Subject: Comments to Proposed Rule and Part 61 Guidance, Low-Level Radioactive Waste Disposal, 80 FR 16082 and 80 FR 15930

**Subject: Comments to Proposed Rule and Part 61 Guidance, Low-Level
Radioactive Waste Disposal, 80 FR 16082 and 80 FR 15930**

COMMENTS ON THE PROPOSED REVISIONS TO 10 CFR PART 61

COMMENTS ON NUREG-2175, GUIDANCE FOR CONDUCTING TECHNICAL ANALYSES FOR 10 CFR PART 61

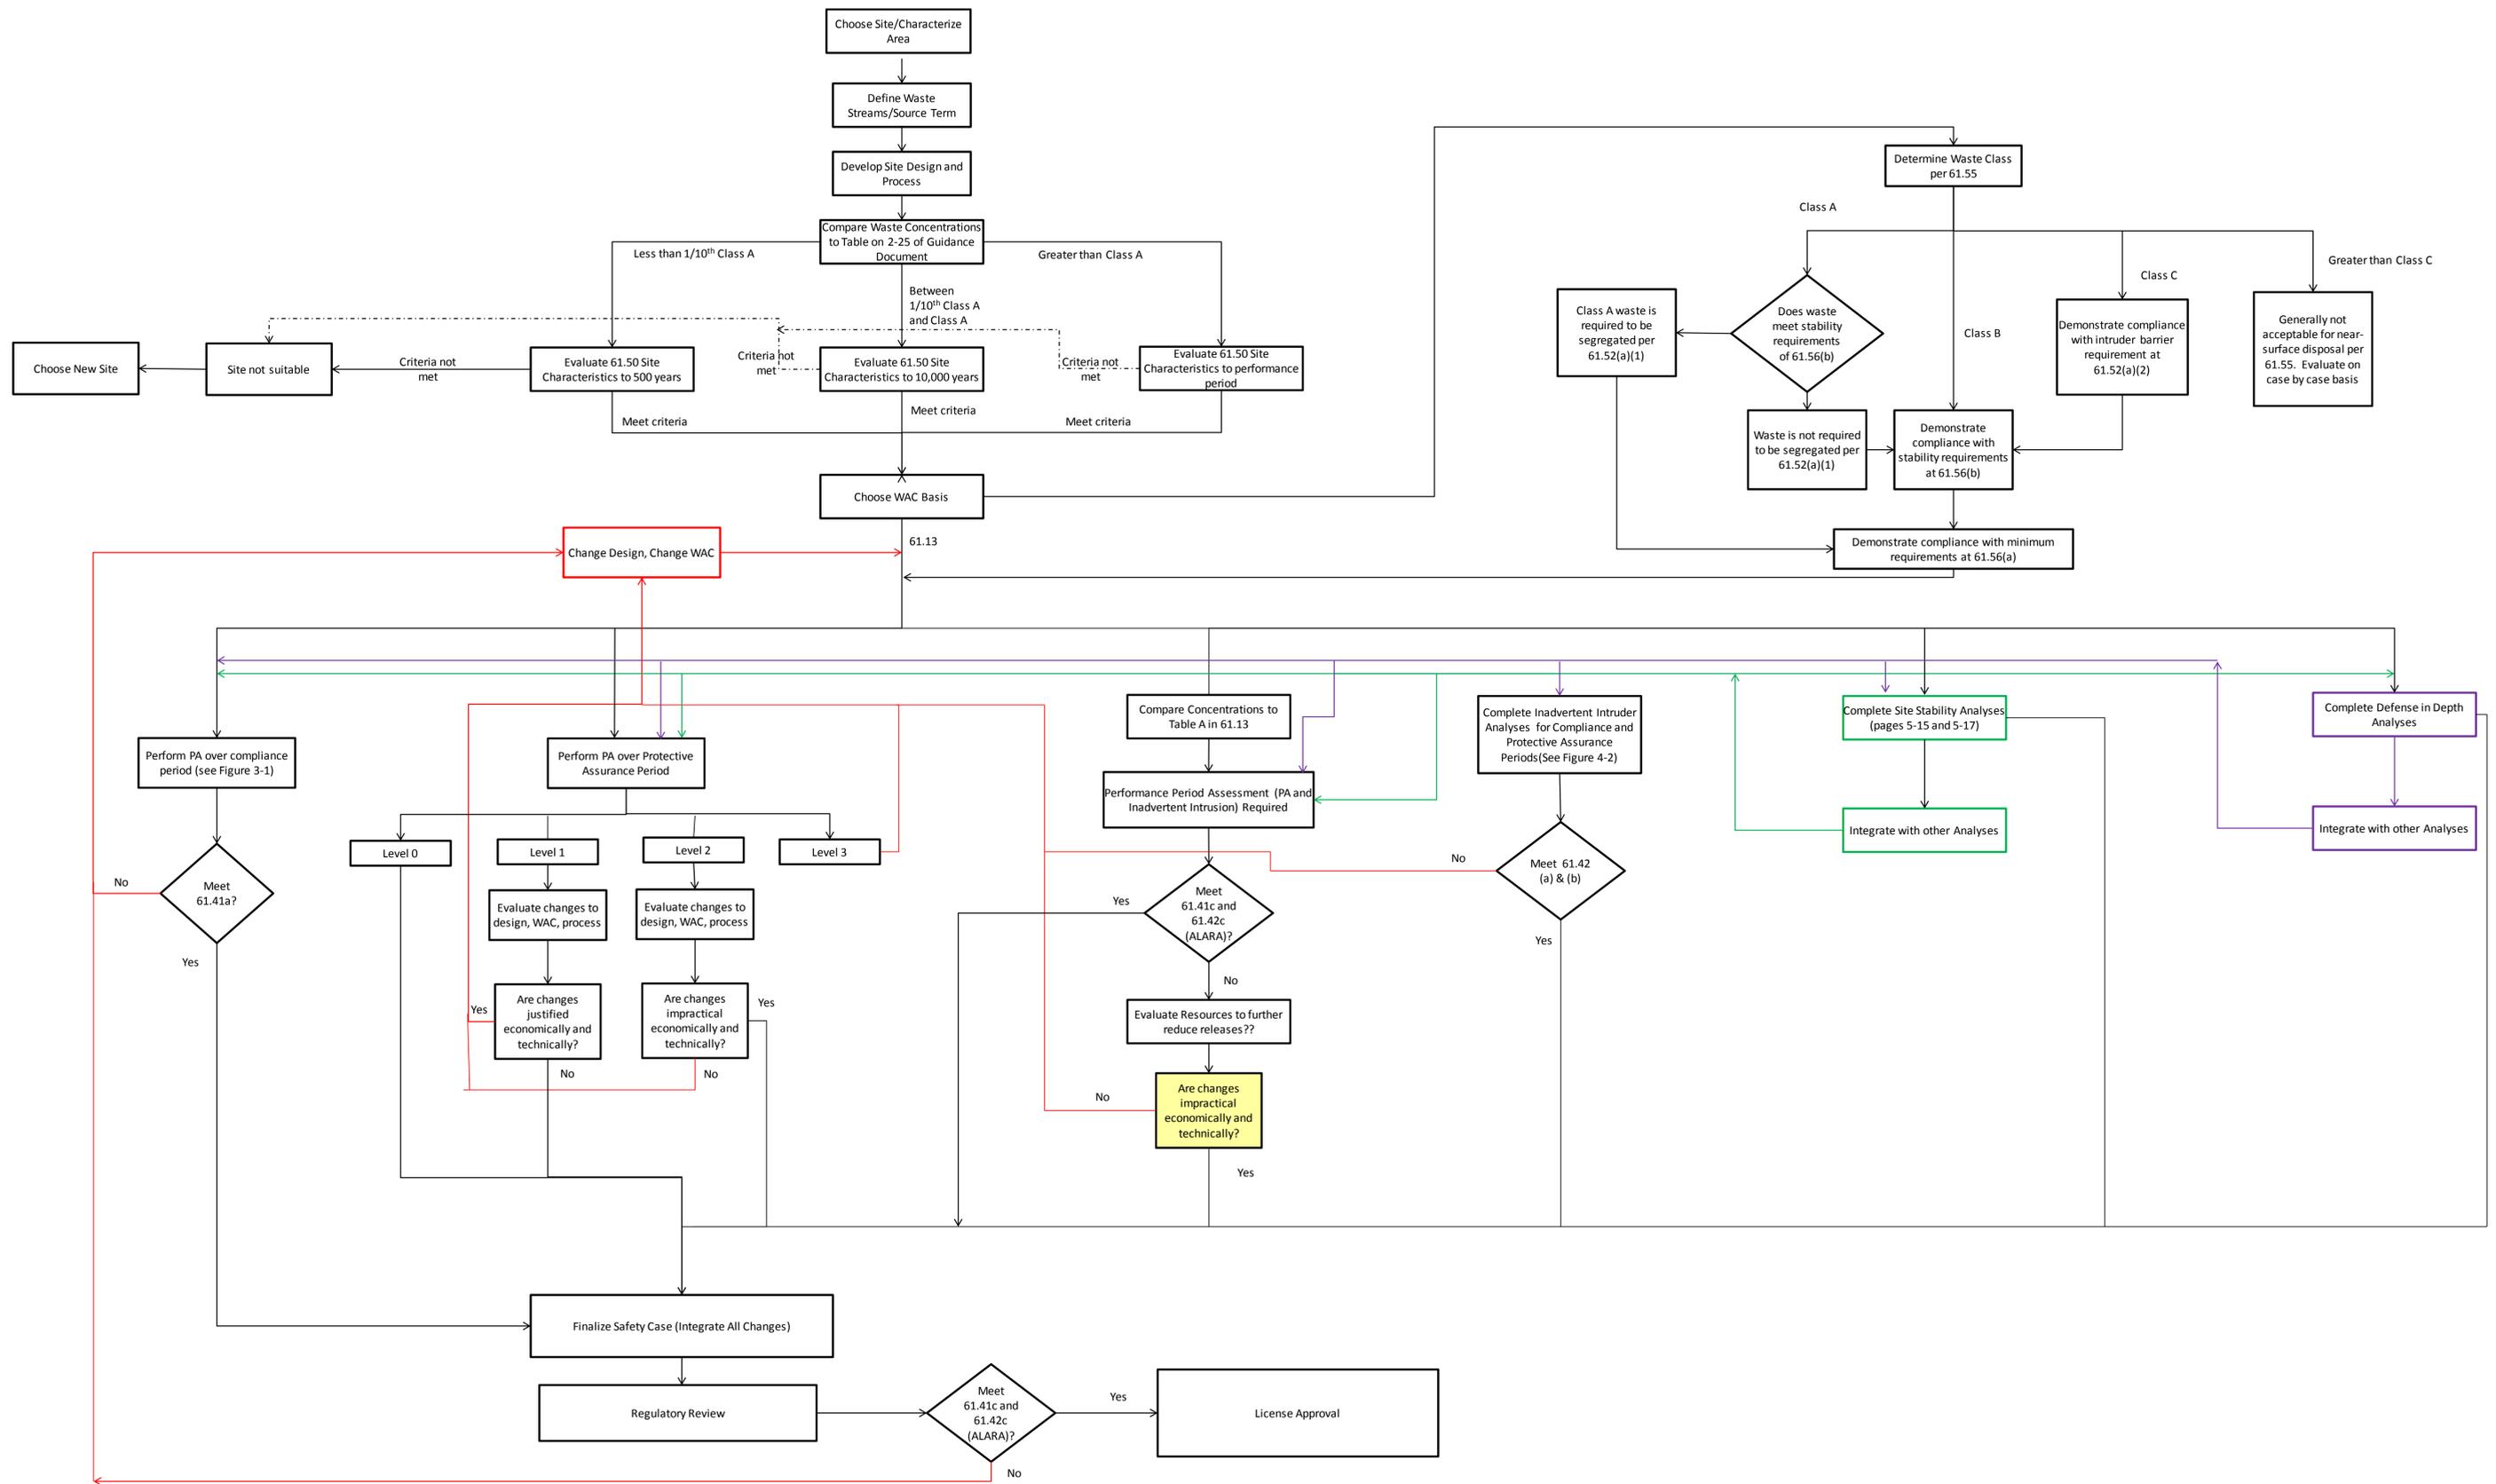
We attempted to create a flowchart to fit the pieces of the proposed rule together (see Figure 1). This flowchart clearly illustrates the cumbersome nature of the process. We recommend several changes that should streamline the process, including using a two-tier system. These are discussed in further detail in the following sections.

Recommendation – We propose that the NRC include a flowchart of the process so that an applicant or licensee can understand the components, requirements, key decision points, and how they fit together.
